PLAN COMMISSION MEETING AGENDA

Plan Commission Report

**City of Oak Creek – Planned Unit Development (PUD)
Conditions and Restrictions**

PROJECT: Plan Review – Mark TeGrootenhuis, HSA Commercial (Froedtert)

18 SECURITY GATE DETAIL
N.T.S.

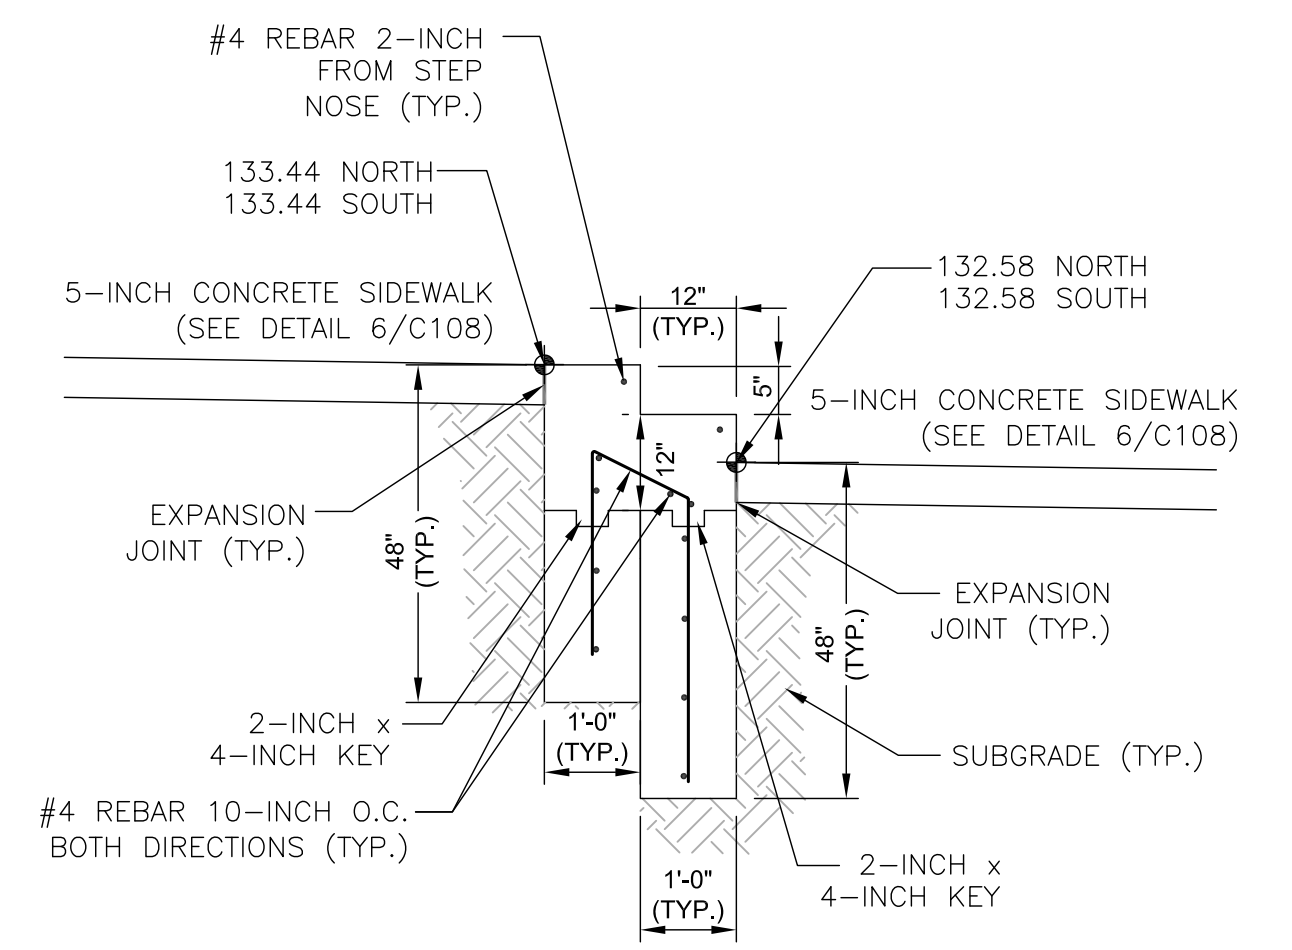
3. That staff comments regarding the north (gate extension, width reduction) and south (parallel parking) access drives are incorporated into revised plans.

EXTERIOR
ELEVATION
MATERIALS

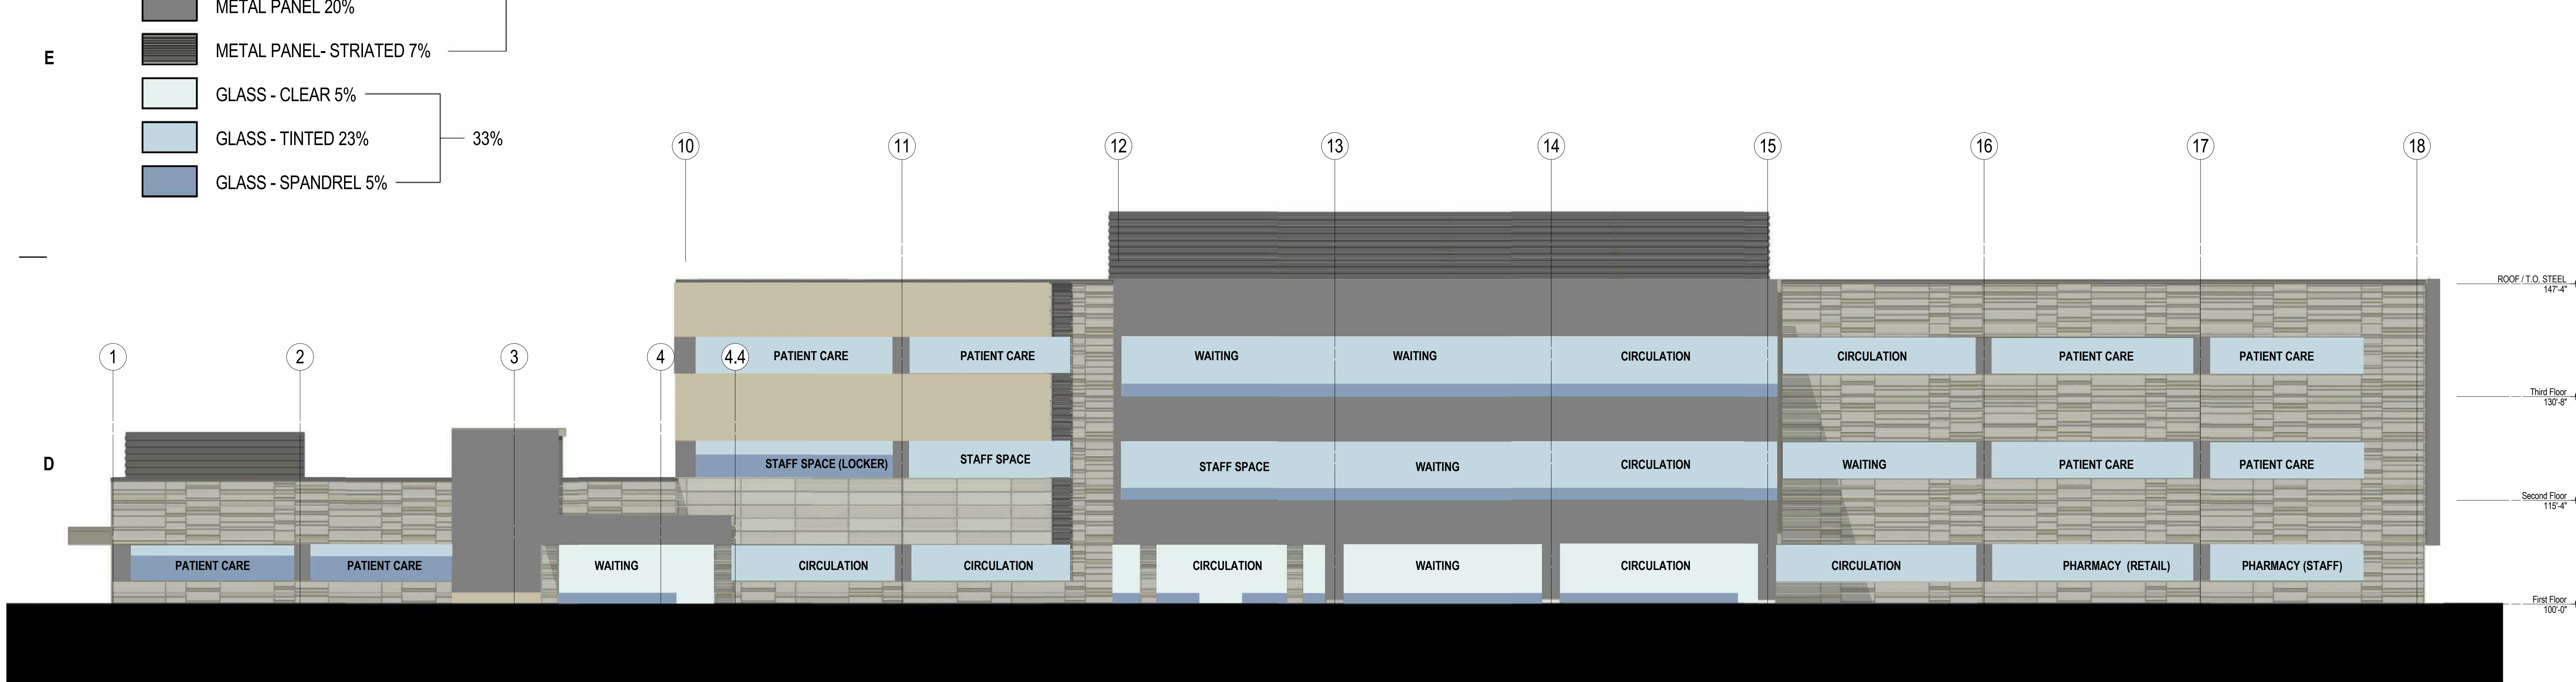
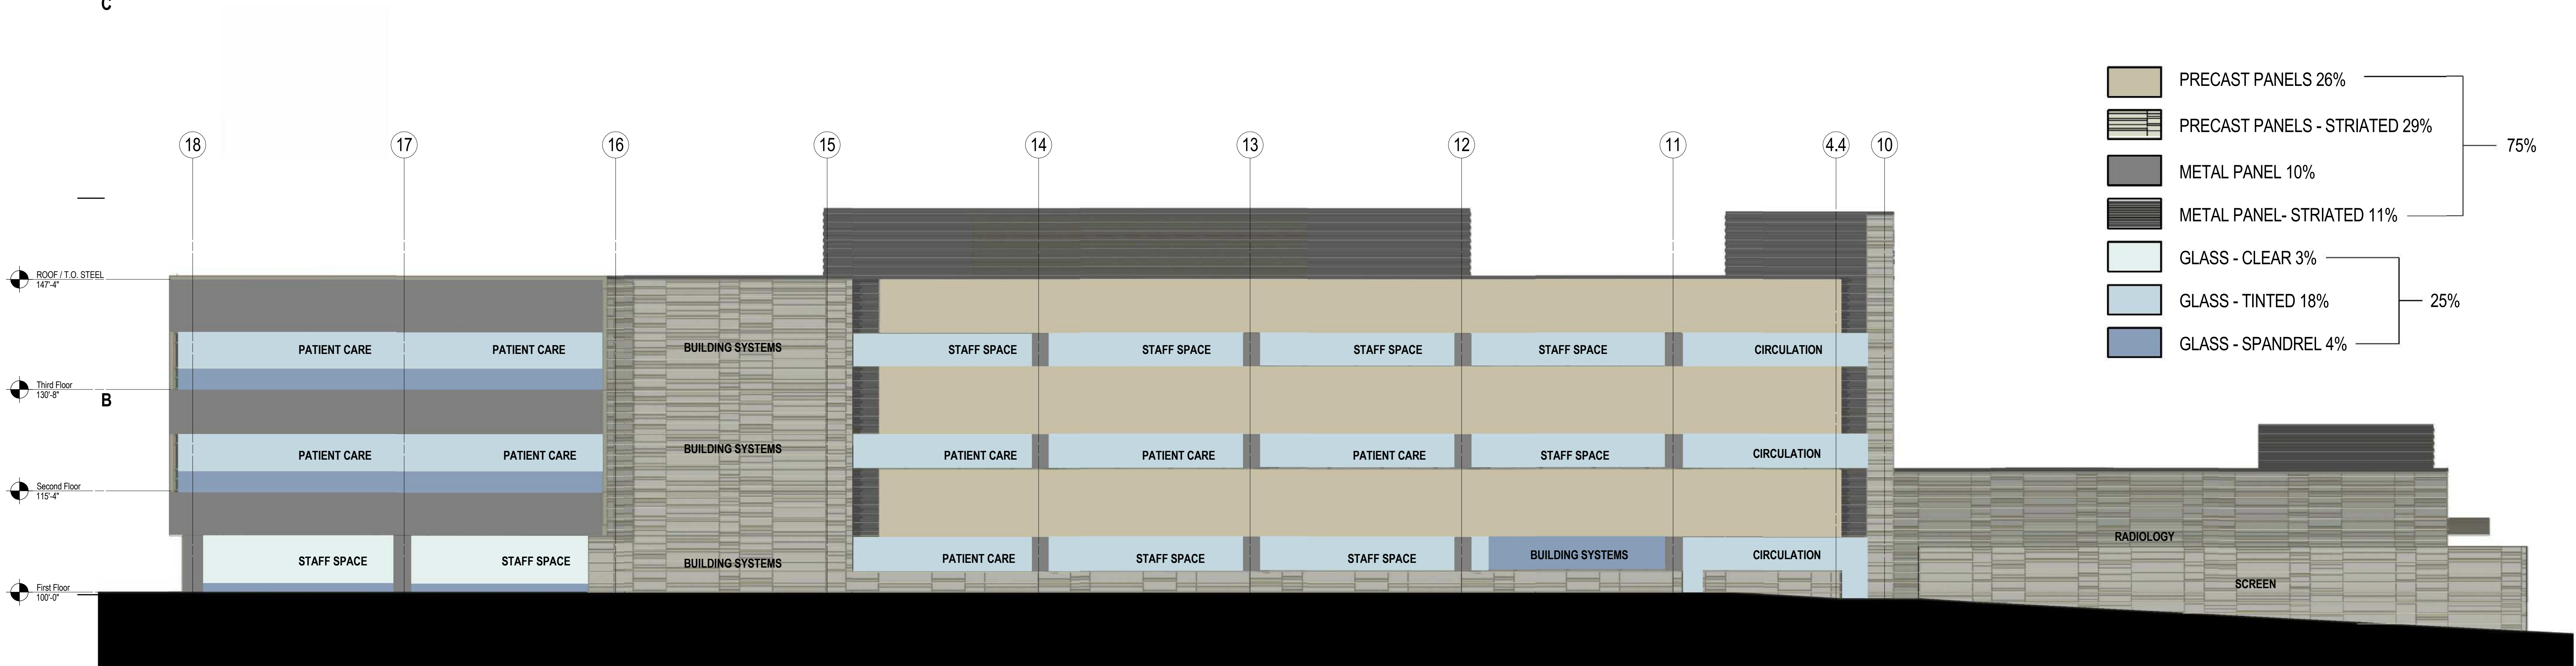
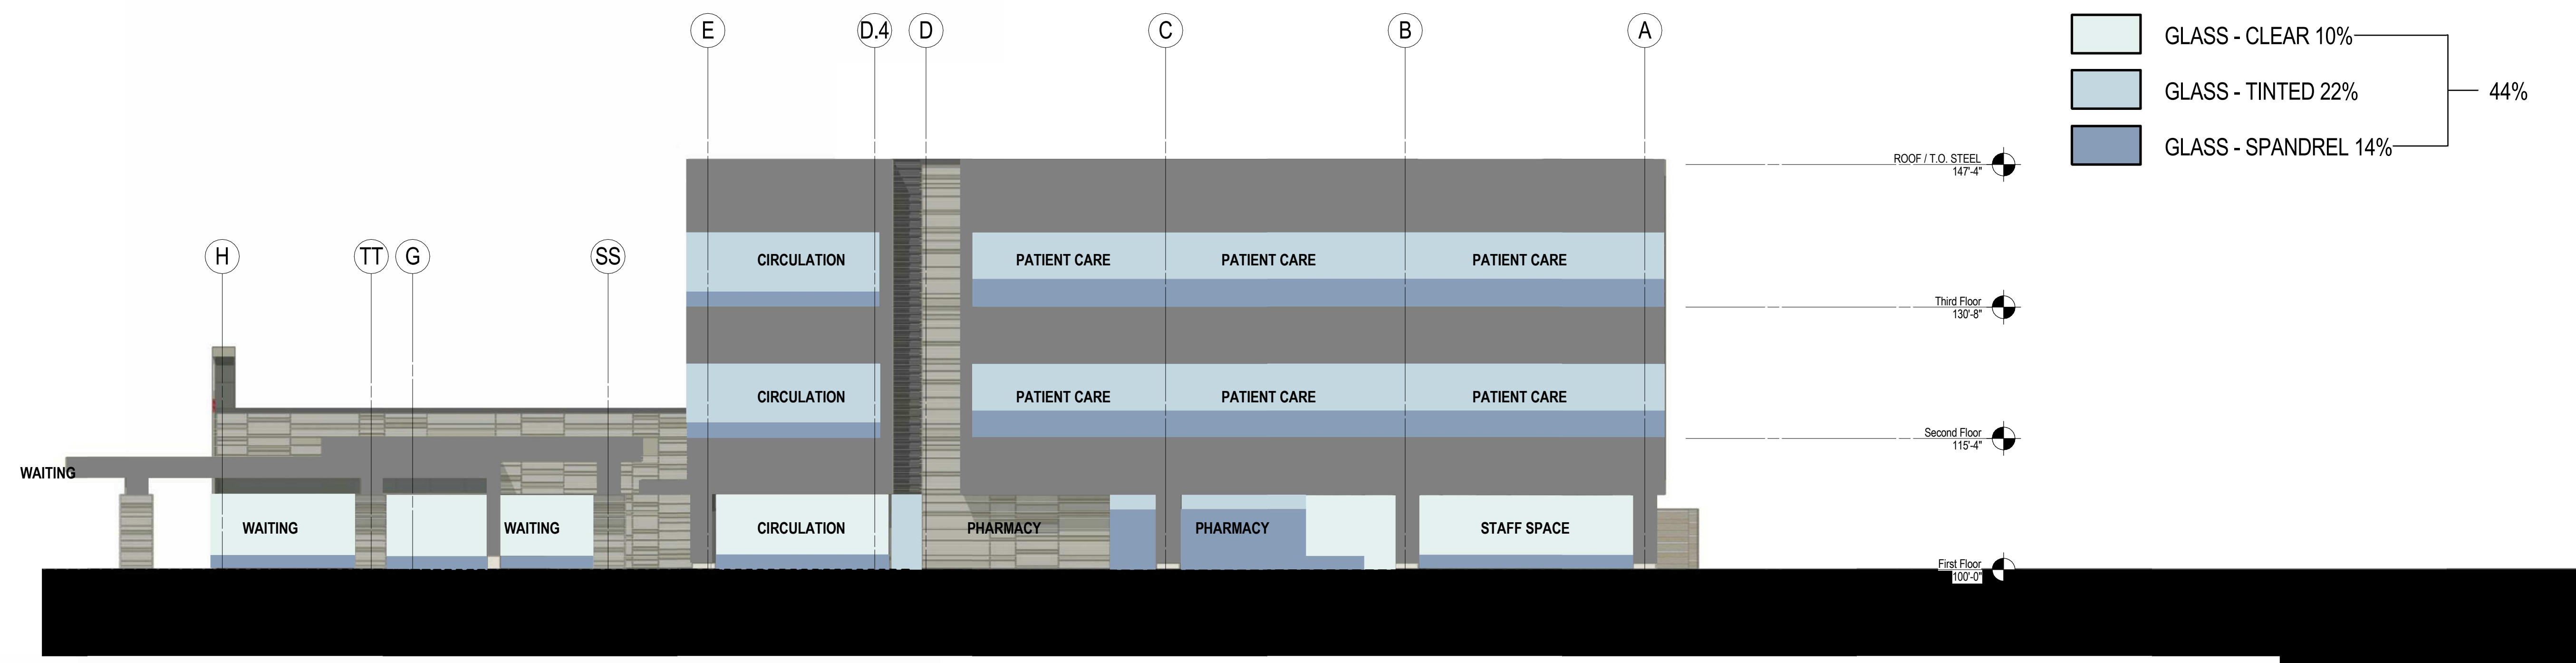
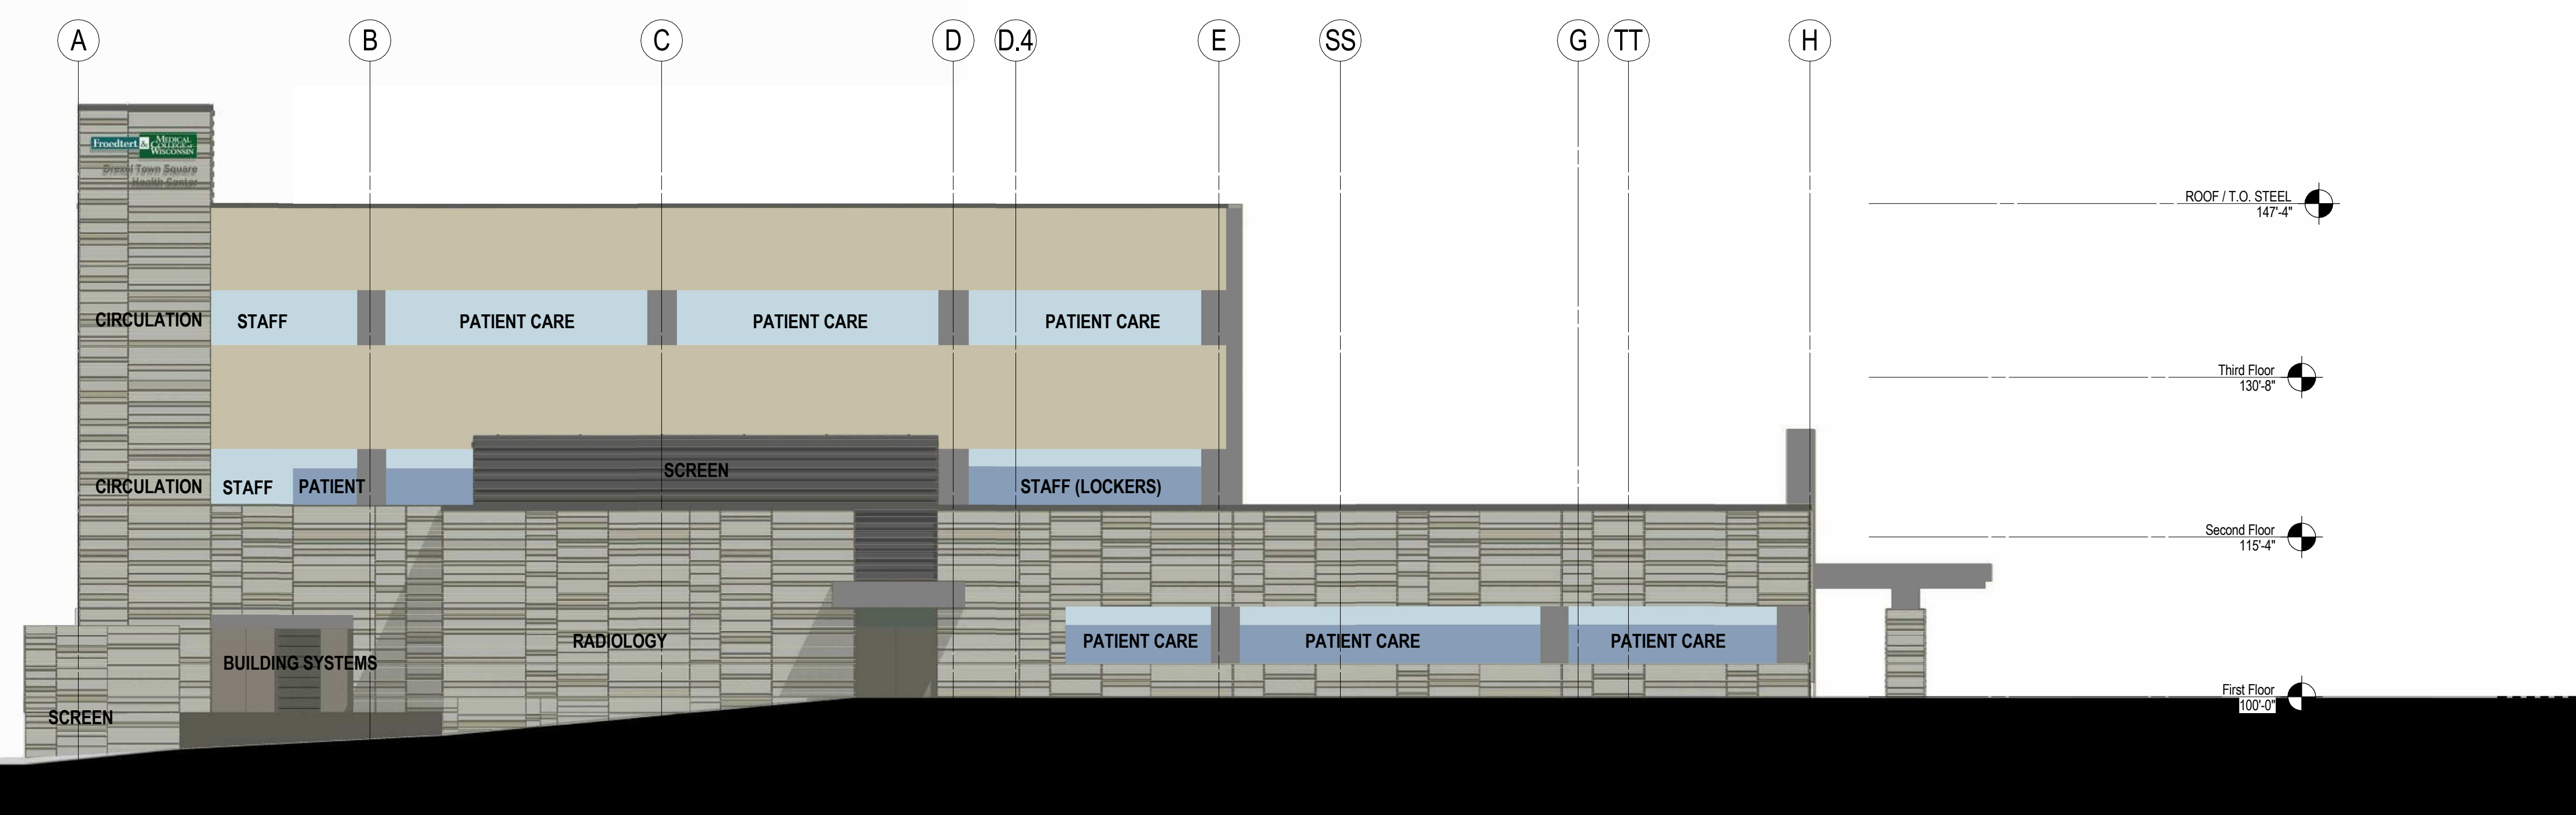
Commissioner Chandler questioned if glazing and required material percentages have been met.
